Groundwater Transfer Review Summary Form

Transfer/PA # T- <u>13441 (temporary drought)</u>				
GW Reviewer <u>Michael Thoma</u> Date Review Completed: <u>05/27/2020</u>				
Summary of Enlargement (Same Source) Review:				
\square The proposed transfer fails to keep the original place of use from receiving water from the same source.				
Summary of Injury Review:				
☐ The proposed transfer will result in another, existing water right not receiving previously available water to which it is legally entitled or result in significant interference with a surface water source.				
Summary of Similarity Review:				
☐ The proposed SW-GW transfer doesn't meet the definition of "similarly" as per OAR 690-380-2130.				
This is only a summary. Documentation is attached and should be read thoroughly to understand the basis for determinations.

571	ATE OF OREGON	Ground Water Review Form				
WATERARIES	WRD S S	Dregon Water Resourd 25 Summer Street NE, alem, Oregon 97301-12 503) 986-0900 www.wrd.state.or.us	Suite A	☑ Water Right☐ Permit Ame☐ GR Modification		
				\square Other		
Application: T- <u>13441 (temporary drought)</u>				Applicant Name	e: <u>Hoefler Brothers LLC</u>	
Propo	sed Changes:

Hydrograph for wells in the area of the proposed and authorized POAs showing hydraulic continuity between sites.

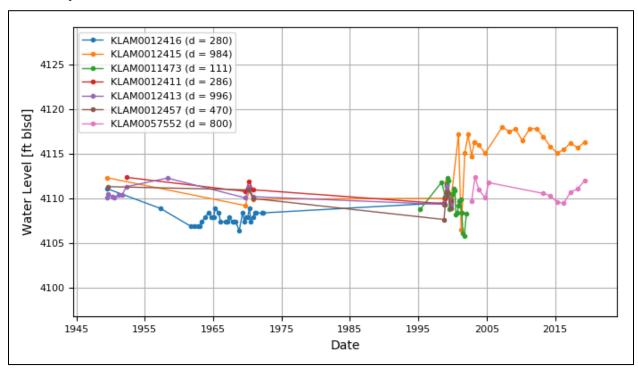
-	ovided in the app proved because:	lication is insuf	ficient to evaluate v	whether the proposed	
	The water well reports provided with the application do not correspond to the water rights affected by the transfer.					
	The application does not include water well reports or a description of the well construction details sufficient to establish the ground water body developed or proposed to be developed.					
	Other					
<u>th</u> <u>P</u> <u>C</u> <u>P</u>	ne POU on the OA on Cert. Cert. 20707 au OA would tra	ree certificates (C 20707 for use on athorizes use on 2 ansfer approximate	Cert. 27209, Cert.	t. 22851, and Cert. 2 m KLAM 12415 to max rate of 2.79 cfs	. The proposed change in KLAM 12416. The	
<u>tv</u> <u>le</u>	Will the proposed POA develop the same aquifer (source) as the existing authorized POA? Yes Do Comments: Despite the difference in completed total depth between the two wells, they report similar static water levels. Both wells also report similar static water levels with surrounding wells completed to various depths between 100 and 1000 ft, suggesting a vertically-continuous aquifer system.
